Retorque Idler Pulley –
Supercharged Vehicles –
Service Action S151

MODEL 2003 MY
S-TYPE R

VIN M48607-M59563

ILLUSTRATION 1

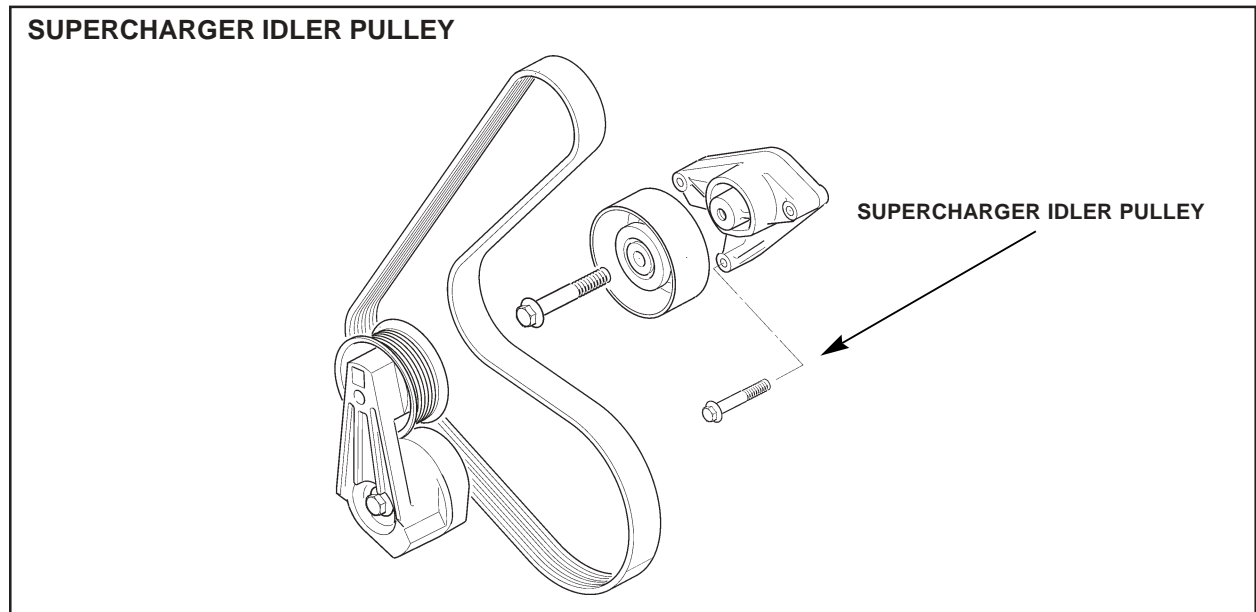
On 4.2L Supercharged S-TYPE vehicles within the above VIN range the supercharger idler pulley bolt has been incorrectly torqued to 25 Nm instead of the specified 40 Nm. If the bolt becomes loose the idler pulley may oscillate causing a loss of tension of the supercharger drive belt. This will cause a loss of drive to the supercharger. Vehicle which have not been checked at the ports are listed in this bulletin.

1. Open hood and fit fender covers.
2. Locate the supercharger idler pulley (Illustration 1).

At the next available opportunity, apply the correct torque of 40 Nm to all vehicles listed on the attached VIN list.

3. Using a 15 mm AF standard socket and a suitable torque wrench, set to 40 Nm, torque the bolt to 40 Nm.
4. Remove covers protectors and close hood.
